M/S Stylers International Ltd. - Unit 2 (Raiwind)

Structural Safety Inspection Report

Observations & Actions

Pakistan Accord Initial Safety Inspection Report

Figure 2.2 - Location of Impact Damage on Columns at Ground Floor of the Mill Building

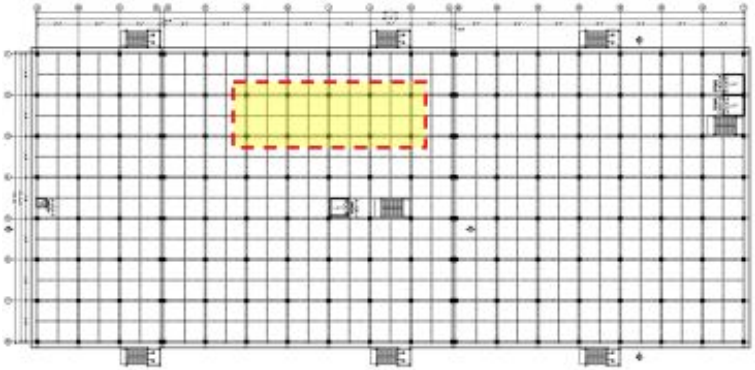
This issue refers to the ground floor washing area of the mill building.
Impact damage was observed on multiple columns within the washing area, likely due to the trolley movement. The damage is limited to minor surface abrasion of the concrete, with no significant depth or exposure of reinforcement noted. At present, the issue is of low structural severity; however, continued impact may lead to progressive deterioration.F-202604-064932

Timeline	Remediation Plan
Medium Term CAP-0076858	Repair damage to column corners and external faces.
Medium Term CAP-0076859	Install protective measures to prevent damage recurring, particularly in areas subjected to trolley and machinery movement within the factory.
Longer Term CAP-0076860	Continue to monitor condition of columns in highly trafficked areas.
